Product Change Notification (PCN)

Subject: SBL(M)G2 and SBLG2 motor drive series plastic cover change

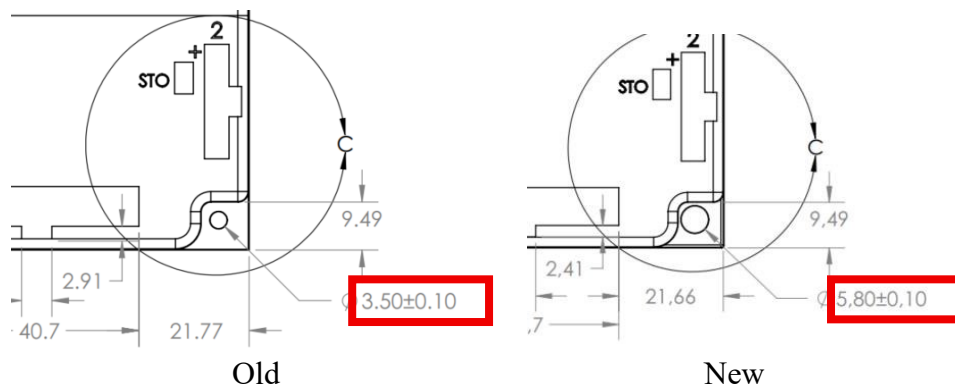
- **Type of Change:** Product Specification
- **Detailed Description:** The plastic cover of SBL(M)G2 motor drive families was changed. Specifically, the diameter of the screws opening on the plastic cover was changed from 3.5mm to 4.8mm.

- **Reason for Change:** There was significant feedback, it was identified that there were incidents where the plastic case was damaged due to the application of extreme torque on the mounting screws. Apart from this, there is the intention to provide multiple low inductance electrical connections between the chassis and the PCBA.

- **Compatibility:** Customers may have issues with the length or the head of the mounting screws they are using.

- **Customer Action:** Review changes, use the latest step file from RoboteQ website in your modeling. Clarify if screw part number change is required from your side.
- **Support and Assistance:** Our dedicated support team is available to assist you during this transition. For any questions or additional support, please contact us:
 - **Technical Support, using [Roboteq Helpdesk](#):** Get help with technical questions and product testing.
 - **Customer Service, e-mail sales.roboteq@mail.nidec.com, tel. +1 (480) 664-6660:** For order placement, tracking, and general inquiries.
